From: Joshua Hagenson <josh@bmplusg.com.au>
Sent: Friday, 5 November 2021 3:29 PM
To: 'Eddie Abramian'
Cc: Mardi Christian; Brian Maguire
Subject: RE: SSD-9579147 Pendle Hill High School - B4 External Walls and Cladding

From: Eddie Abramian <eddiea@taylorau.com.au>
Sent: Friday, 5 November 2021 1:49 PM
To: Joshua Hagenson <josh@bmplusg.com.au>
Cc: Mardi Christian <Mardi.Christian@tsamgt.com>; Brian Maguire <brian@bmplusg.com.au>
Subject: SSD-9579147 Pendle Hill High School - B4 External Walls and Cladding

SSD CONDITION	REQUIREMENT
B4	Prior to the commencement of construction, provide a copy of the completed external wall design disclosure statement (refer to the attached proforma) along with accompanying AS 1530 Test Reports as evidence that the materials which are attached to and forming the external walls are non-combustible or comply with Clause C1.9(e) of the BCA. Provide evidence of submission of the documentation to the Planning Secretary within seven days after BMG accepts it. 04/11/21 – There are various options identified for the proposed sarking type material. Each of the supporting documentation for the products makes reference to a previous edition of the BCA and/or c

FIGURE 2.9 TYPICAL DETAILS OF MEMBRANE TERMINATION AT WALL OPENINGS WHERE THE INTERNAL AND EXTERNAL FINISHED FLOOR LEVELS DO NOT ALLOW FOR AN UPTURN

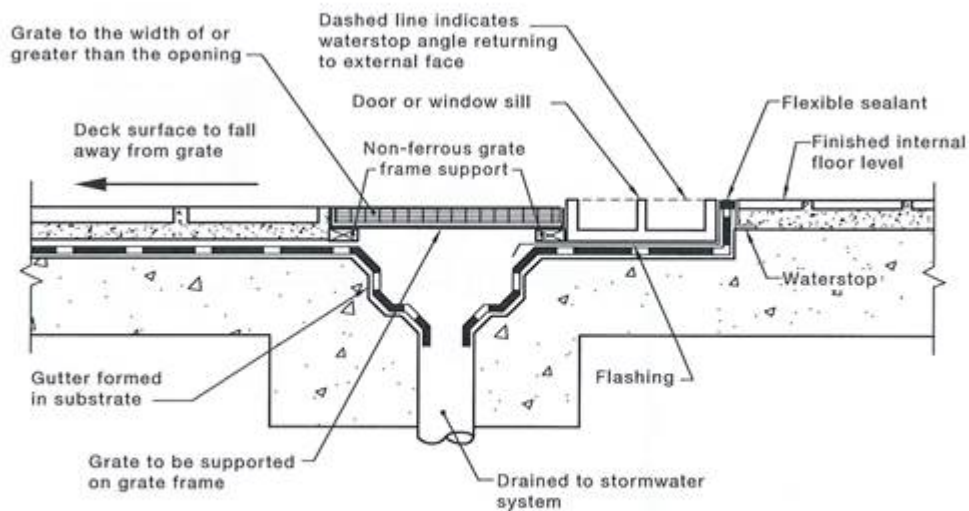
- b. Glazing complying with AS2047 including, sealing to all junctions and lapped glass where permeant vent windows are proposed
 - c. The use of strip drains at doorways to allow for seamless thresholds for accessibility whilst preventing water ingress (see figure below from AS 4564.2-2012, whilst not an adopted standard under the BCA, provides good guidance on weatherproofing at level door thresholds. Alternatively, where a canopy or roof overhang is proposed and provides a degree of weatherproofing, consideration may be given to a 35mm high threshold ramp (complying with AS 1428.1-2009) at the doorway together with a 1:40 fall away from the door to assist with shedding water
